<i>NCSX RFD</i> <i>Part I</i>	Number: 14-022	RFD Description: Reorientation of Type B MCWFs Lead Slots
Initiator: Phil Heitzenroeder		Organization: PPPL
List of Impacted Documents: <i>(Specification, MIT/QA Plan, SOW, drawing, etc.)</i>		
Cost Impact: <i>(If none, so state): NONE</i>		
Schedule Impact: <i>(If none, so state): NONE</i>		
Quality Impact: <i>(If none, so state): NONE</i>		
State Requirement Deviation is Requested For: <i>(Specification, MIT/QA Plan, SOW, drawing, etc.):</i> SE141-115, Sheet 7, Quad B4		
<p>Full Description of the Deviation Requested: <i>(Use continuation pages, e-mails, letter, sketches, etc. as needed and include amplifying information as appropriate to support deviation request.)</i></p> <p>A NCSX Project-initiated modification to improve the lead block positioning resulted in a slight reorientation (2.2° horizontal change at the top and 0.114” vertical change) of the lead slots as shown on Attachment (1).</p>

Rapid Response Transmittal Concerning the Type B Lead Slots

Attachment (1)

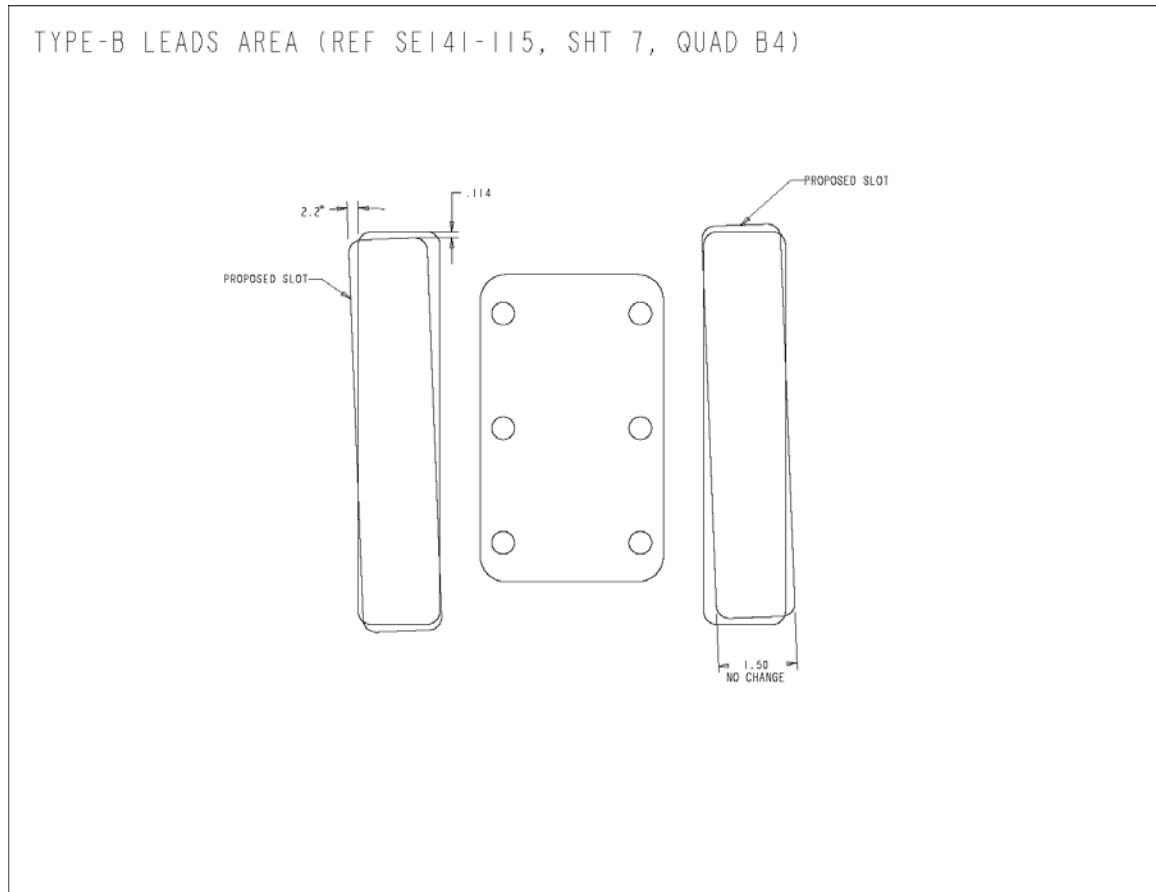
A NCSX Project-initiated change resulted in a reorientation of the lead slots in the Type B MCWFs as shown below. EIO is requested to immediately implement this change. A drawing change is in progress and a formal Request for Deviation will be issued within 2 days.
